# Access Compliance Report

## Public Rights-of-Way

### (Curb Ramps)

Intersection ID: 50768	Main Street: TOWERING_PINE_DR	Cross Street: SUTTONVIEW_DR	Location: SE
ADA ID: 76553F1A2088	Ramp Type: Perp	Initial Pass/Fail: Fail	Overall Compliance: No
Severity Score: 10			
Codes/Mitigation Info/Possible Solution		Field Measurements/Component Compliance

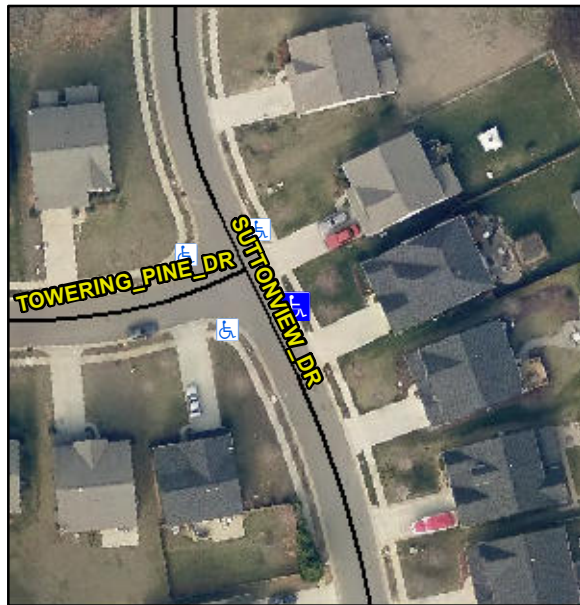
**Not Found, R304.5.1, R304.5.3**

Compliance	Description	Data	Compliance	Description	Data
N/A	Ramp Length (in)	47.0	Yes	Ramp Slope (%)	5.1
No	Ramp Width (in)	47.5	No	Ramp XSlope (%)	3.6
N/A	Flare Type LT	N/A	N/A	Flare Type RT	N/A
N/A	Flare Slope LT (%)	N/A	N/A	Flare Slope RT (%)	N/A
N/A	Flare Traversable LT?	N/A	N/A	Flare Traversable RT?	N/A
N/A	Landing Length (in)	N/A	N/A	DWS Provided?	N/A
N/A	Landing Width (in)	N/A	N/A	DWS Contrast?	N/A
N/A	Landing Slope (%)	N/A	N/A	DWS Length (in)	N/A
N/A	Landing X Slope (%)	N/A	N/A	DWS Full Width?	N/A
N/A	Landing Curb? (Y/N)	N/A	N/A	DWS Offset (in)	N/A
N/A	Shared Landing?	N/A			
N/A	Gutter Ponding?	N/A	N/A	Gutter Slope (%)	N/A
N/A	Gutter Lip Ht (in)	N/A	N/A	Gutter X Slope (%)	N/A
N/A	Painted X Walk1?	No	N/A	Painted X Walk2?	N/A
	X Walk 1 Direction	To W		X Walk 2 Direction	N/A
N/A	X Walk 1 Width (in)	N/A	N/A	X Walk 2 Width (in)	N/A
	X Walk 1 Slope (%)	1.9		X Walk 2 Slope (%)	N/A
	X Walk 1 X Slope (%)	2.8		X Walk 2 X Slope (%)	N/A

**Remove & Replace Entire Ramp.**
